**Torrey Pines Community Planning Board Regular Meeting**

Thursday, November 11, 2020 **APPROVED** Minutes

5. Project Review - Villa Montana CD/PDP/TM Project 653845  
Project Manager: Edith Gutierrez, EGutierrez@sandiego.gov  
Applicant: David Smith 858.831.0111  
Adam Gevanthor, PRC Chair, presented PRC overview. (Slides attached to minutes. "3 Villa Montana PRC Presentation")

# Villa Montana

# Site Plan

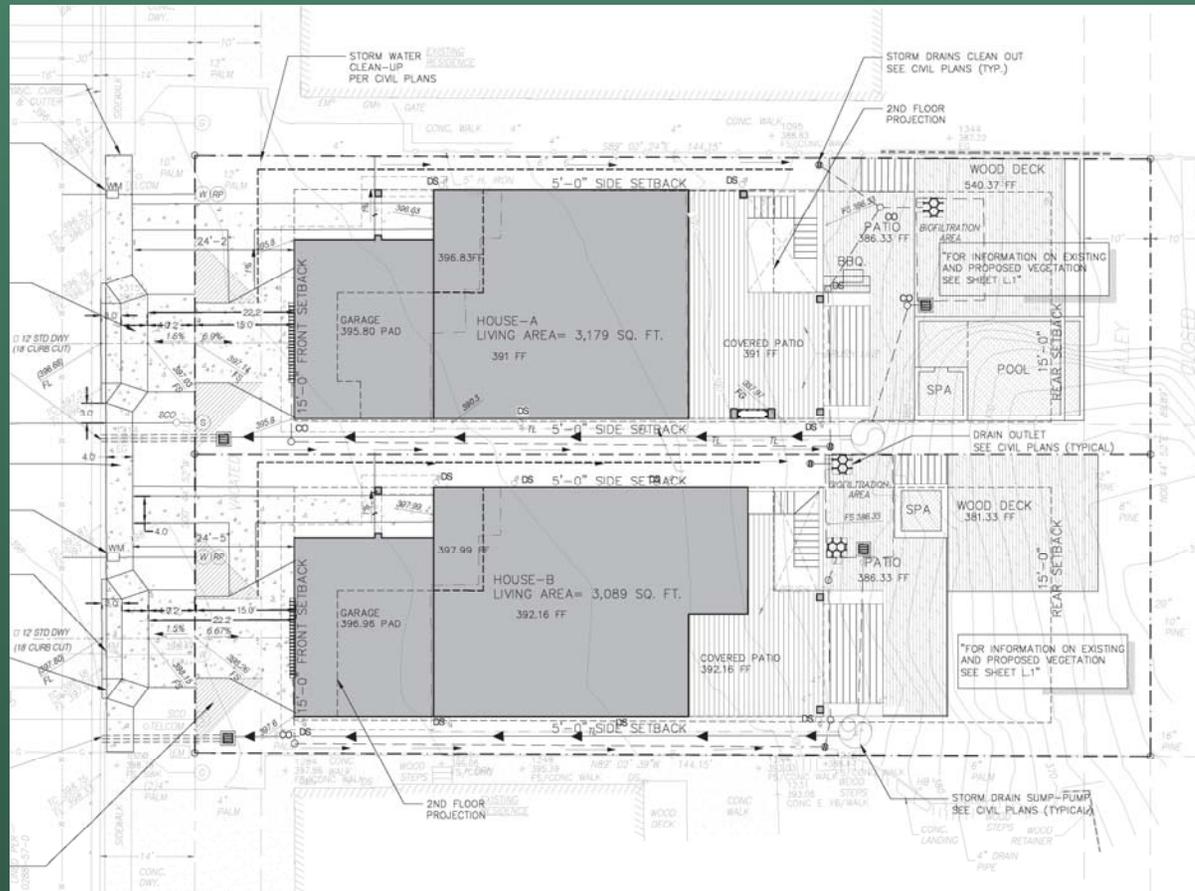
- ▶ Applicant returned a third time at which point a number of neighbors were in attendance with concerns about the project.
  - ▶ Remaining Issues:
    - ▶ Lack of landscape buffers between project and adjoining neighbors,
    - ▶ Adequacy of lemon tree as “street tree” in front yard to buffer architecture from view.
    - ▶ Vegetation treatment along slope where staff identified sensitive species.
    - ▶ Impact of rear decks to neighbors below and encroachment into alley right of way. Requested cross section through property to enable study of height relationship with neighbors below.
      - ▶ It appears deck is approximately 20' above residences located along Mango Drive.
    - ▶ Whether substandard size of proposed lots compatible with immediate neighborhood – Not Del Mar Heights as a Whole.

- ▶ 1. Applicant addressed architectural concerns
  - ▶ 2. Landscape concerns partially addressed, issues remain
  - ▶ 3. Lot size study requested and not received

- ▶ 3. **Didn't feel that subdividing the project into smaller lots would result in a more desirable project as required per Finding #3** and that based on the lot sizes in the IMMEDIATE NEIGHBORHOOD didn't agree that a smaller lot subdivision was appropriate.

- ▶ RS-1-6 : Min Lot Size is 6,000sf; Min Lot Width is 60ft; Min Lot Depth is 95ft. Applicant seeking deviations via a Planned Development Permit which the decision-maker will either deny, approve, or conditionally approve. Lot size proposed is 45'. Lot area meets minimum.

- ▶ Not consistent with swath of larger lots clustered east to west along mesa top in area immediately adjacent to project.
    - ▶ While smaller 50' lots exist in abundance they are scattered elsewhere and along Mango Dr. Less than 8 or 9 are less than 50' are located elsewhere in neighborhood (confirm).

- ▶ **PRC not willing to support project as presented so we agreed to punt the project to the full Board for consideration.**

# Community Concerns (from meeting & letters)

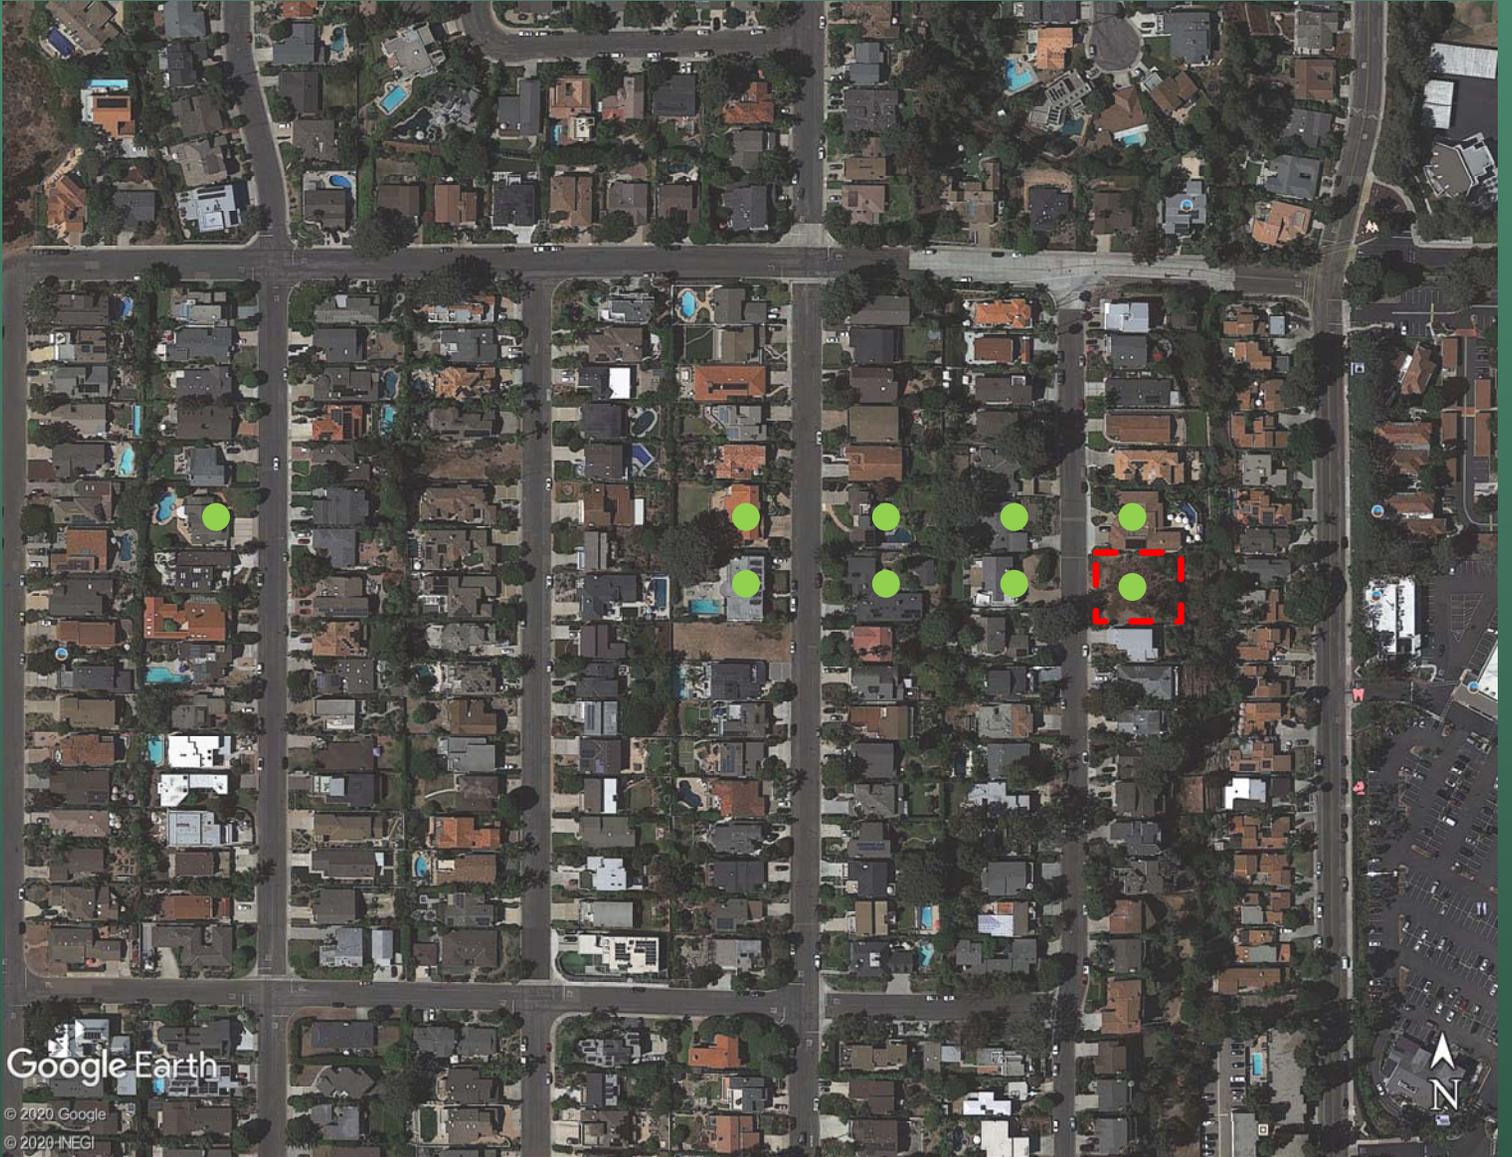
- ▶ 2. Massing of buildings and decks adversely impact downhill side of development
- ▶ 3. Slope stability concerns expressed by neighbors located on downhill side of project.
- ▶ 4. Project encroaches into alley.
- ▶ 5. Lots are overdeveloped and too massive. Will overwhelm homes along Mango Dr. downhill from project.
- ▶ 6. Even smaller lots located on Mango Drive contain homes that are smaller, that don't max out FARs.
- ▶ 7. Questioned whether height limit calculated correctly and that "land to building ration" exceed that allowed
- ▶ 8. Height of decks 20' above homeowners below.
- ▶ 9. Concerns about how drainage being handled and impacts to homeowners below

Sheet Title:  
SITE PLAN

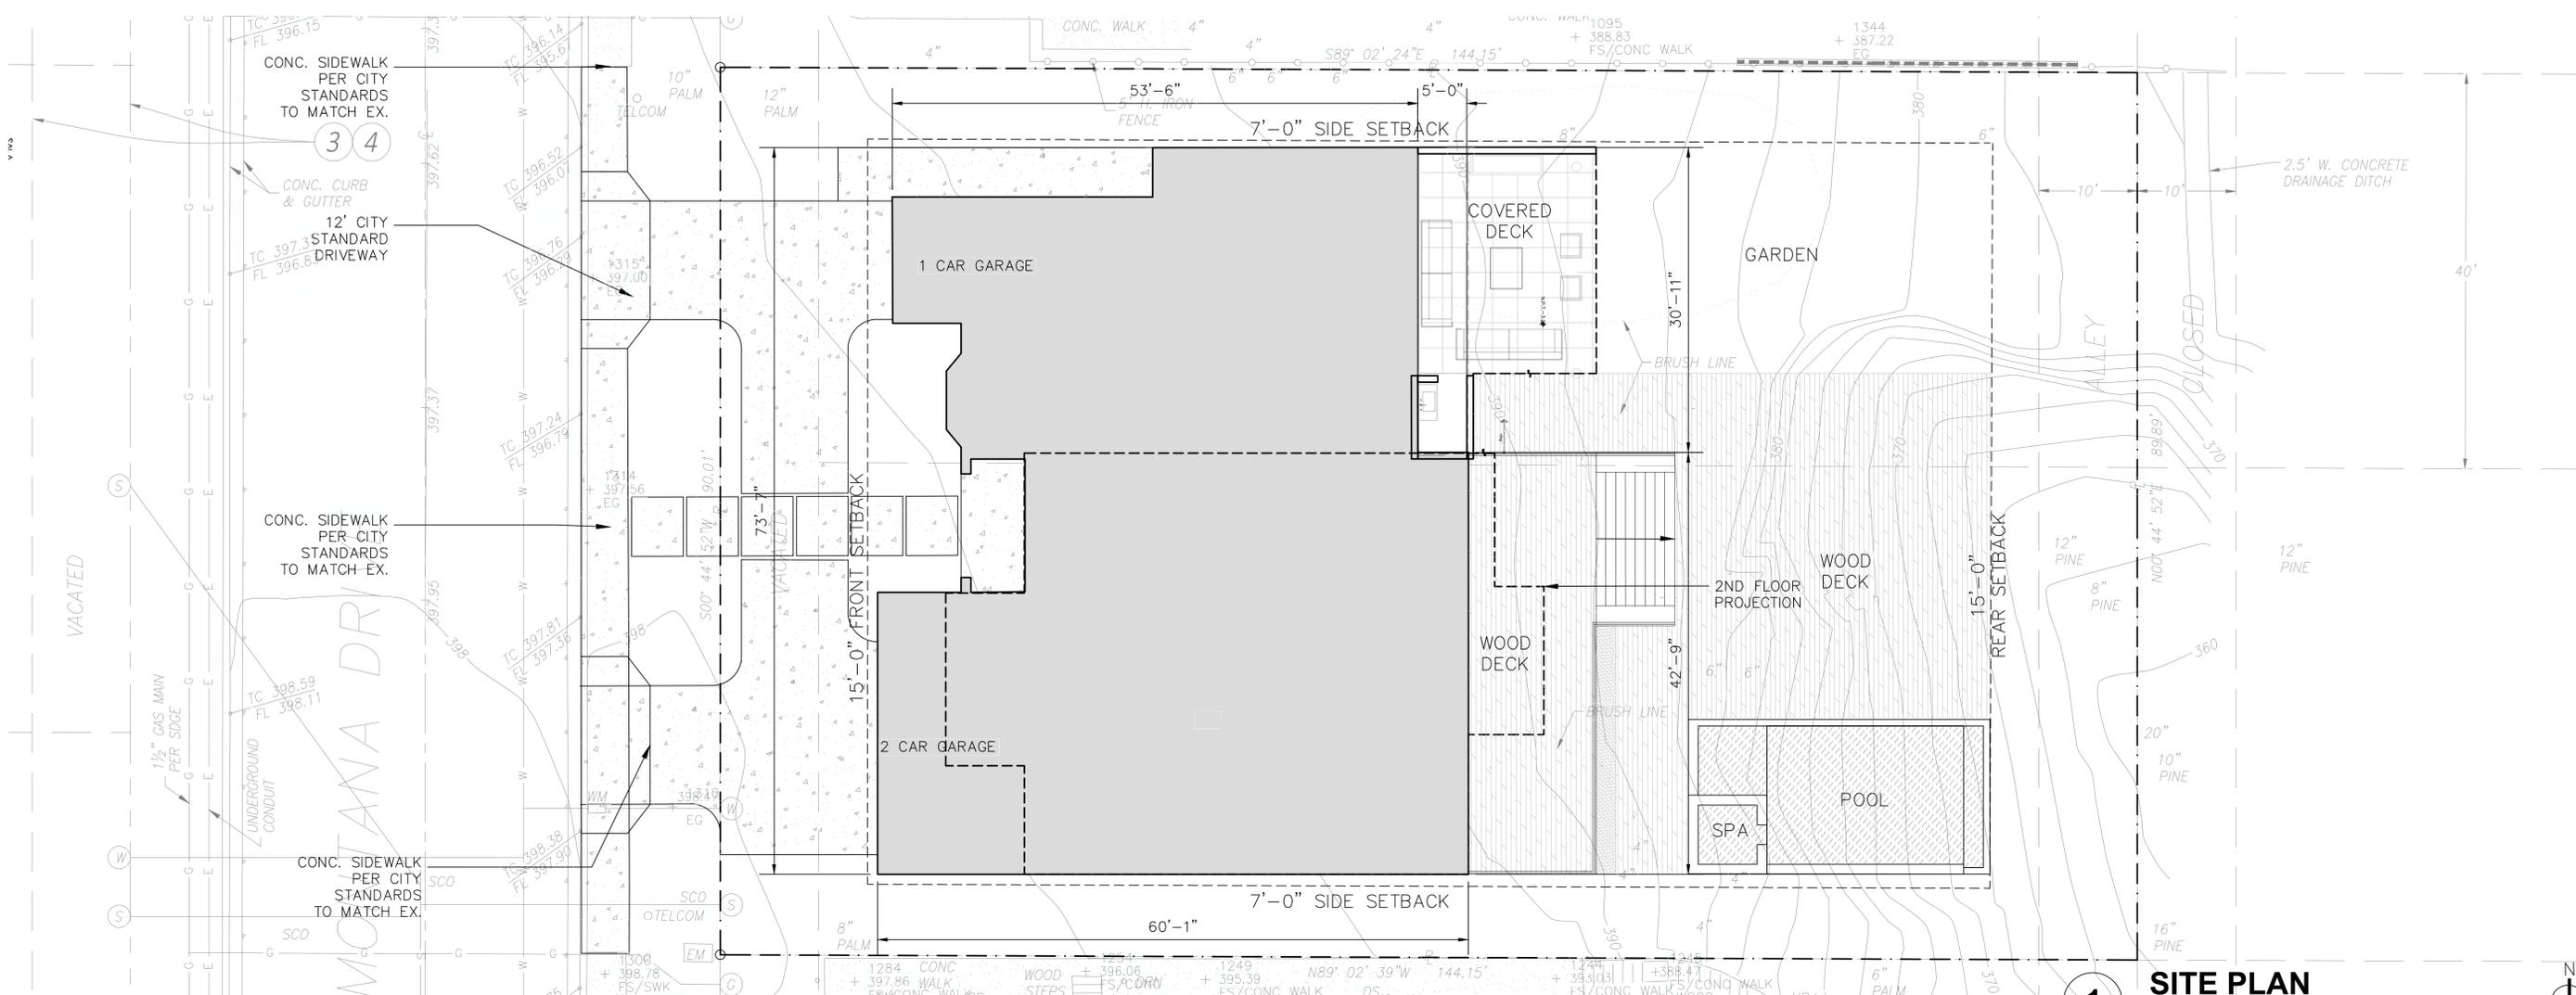
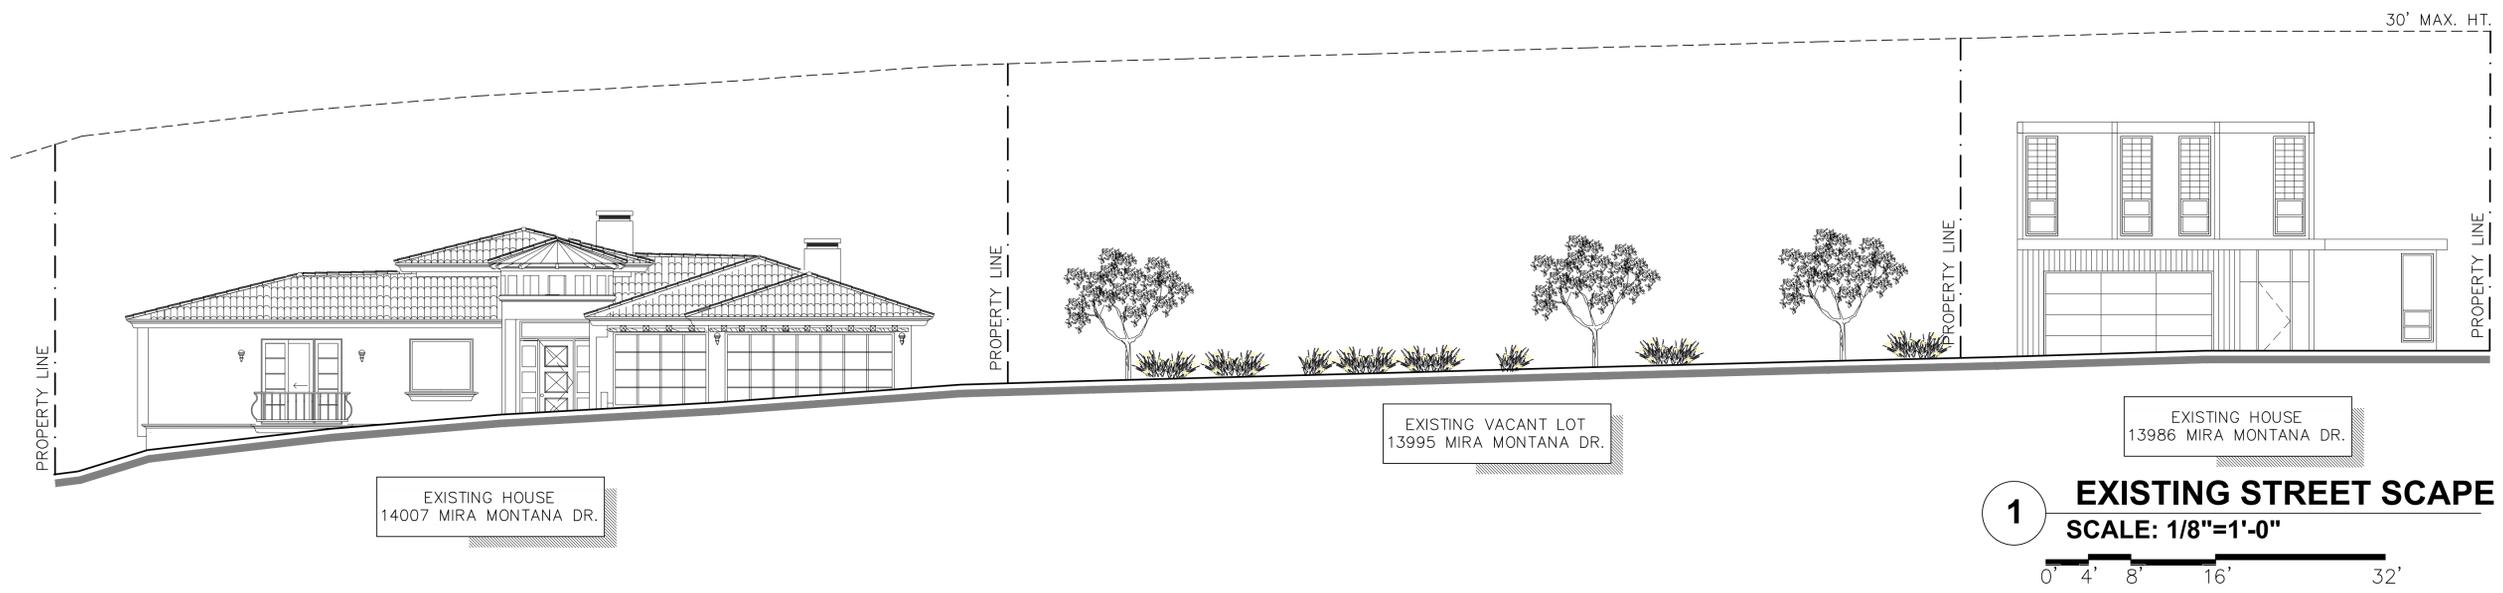
Carlos Wellman presented the project. (Slides attached to minutes. "4 Miramontana-110220"). The owner and architect listened to the neighbors and he presented a fundamentally different project, a single family home with an ADU, with no lot split. (Making Adam's PDF presentation less relevant.)
